We sincerely thank you for the careful and constructive evaluation of our manuscript entitled “**A Compact Fabry-Perot Interferometer with a Solid Etalon for Measuring Upper Atmospheric Wind and Temperature.**” We greatly appreciate your positive assessment of the scientific relevance and instrumental contribution of this work. The comments have helped us improve the clarity, rigor, and presentation of the manuscript.

Figure 7:

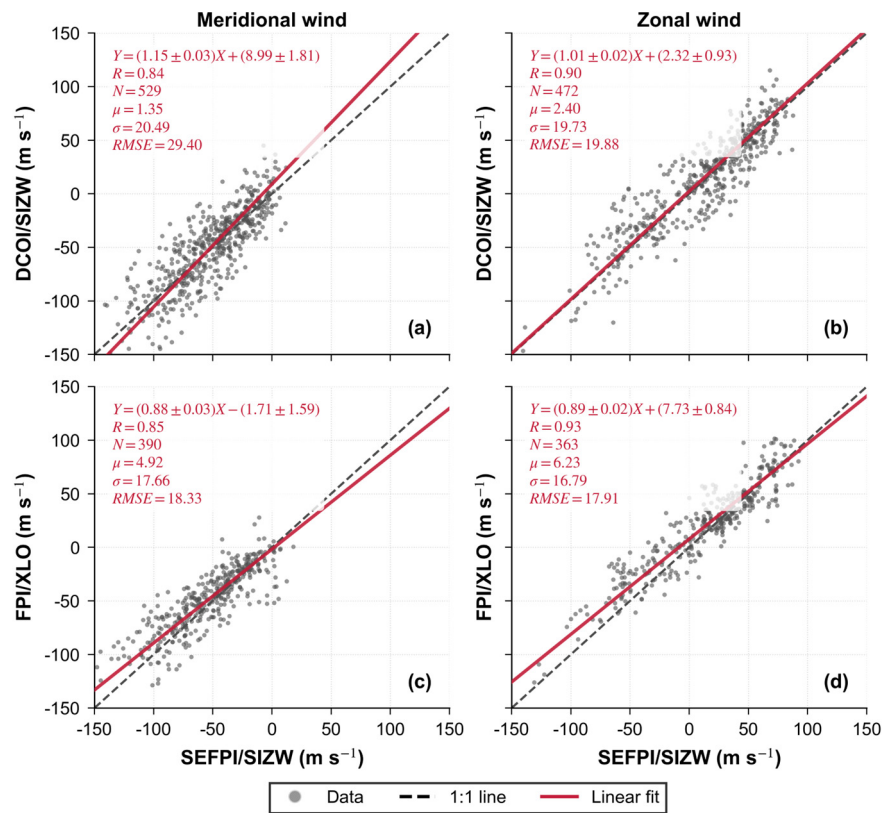
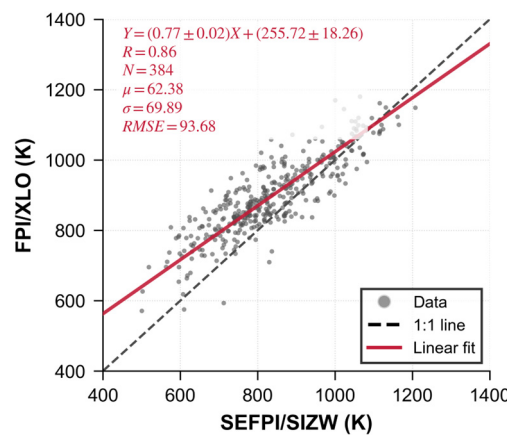
Comment 4: In Fig. 7 and 9, the RMSE can also be provided, together with mean bias μ .

Response: We thank the reviewer for this suggestion. Accordingly, we have added the root-mean-square error (RMSE) to the statistical analysis of the field comparisons. For the wind comparison between the SEFPI and DCOI at the SIZW station, the RMSEs of the meridional and zonal wind components are 29.4 m/s and 19.88 m/s, respectively. For the comparison between the SEFPI at SIZW and the FPI at XLO, the corresponding RMSEs are 18.33 m/s and 17.91 m/s for the meridional and zonal wind components, respectively. For the temperature comparison, the RMSE is 96.96 K.

The RMSE provides a quantitative measure of the overall discrepancy between the SEFPI measurements and the reference observations, while the mean difference characterizes the average systematic offset. Together, these metrics provide a more comprehensive assessment of the agreement and measurement differences among the instruments. The corresponding RMSE values have been added to the relevant panels in Figures 7 and 9 of the manuscript.

The Figures 7 and 9 of the manuscript have been revised as follows:
